Official Transcript of Proceedings NUCLEAR REGULATORY COMMISSION

Title: Advisory Committee on Reactor Safeguards

Metallurgy and Reactor Fuels Subcommittee

A Probabilistic Risk Assessment of Consequential SGTR (C-SGTR) for a Westinghouse and a Combustion Engineering Plants

Impact of changing codes (1/2)

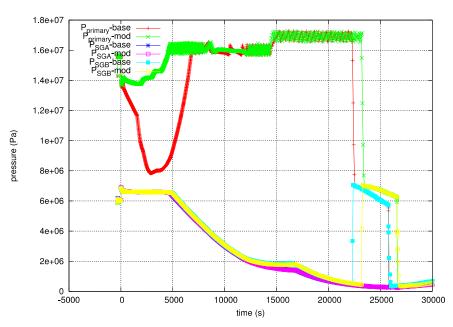
- Both ACRS and public provided comments regarding the impact of changing codes
- Code to use was a major choice at beginning of project
 - RELAP/SCDAP
 - Used for Steam Generator Action Plan (SGAP) work
 - Easy to directly compare results
 - Hot tube modeling and application of CFD already developed
 - MELCOR
 - NRC Severe Accident code
 - Calculate transport and release of fission products

Fig. 8: stsbo decay and oxidation power contribution

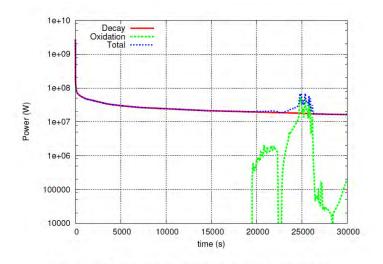
1	There's a question about relative decay
2	and oxidation powers. And there was a comment, I think
3	the question originated because the hydrogen showed up
4	in, I think in, I don't know if it was either
5	presentation or report, there was a plot of hydrogen
6	content in the steam generators and the commenter
7	seemed to consider that perhaps the hydrogen was
8	generated earlier and then held up and then transported
9	to the steam generators. And asked, where was it held
10	up.
11	So as you see here in both the power
12	generation, up top, where green is oxidation power and
13	the hydrogen generation that the hydrogen is actually
14	generated when you see it. And quite later than you
15	see in the Westinghouse analyses.
16	And then there was a question about
17	oxidation of steel in the RCS. It's something that's
18	typically not modeled in severe accident analysis
19	codes. And MELCOR does model it, steel oxidation in

20	the core.
21	Our analysis didn't consider it, but since
22	the question arose we went and looked at the reaction
23	rates. And it doesn't seem to be a major effect.
24	CHAIR REMPE: Just out of curiosity.

- Steel oxidation in RCS components typically not modeled in severe accident analyses
 - MELCOR models steel oxidation in core
 - CSGTR analyses did not consider steel oxidation
 - Reviewed reaction rates
 - Steel oxidation in RCS does not appear to be a major effect
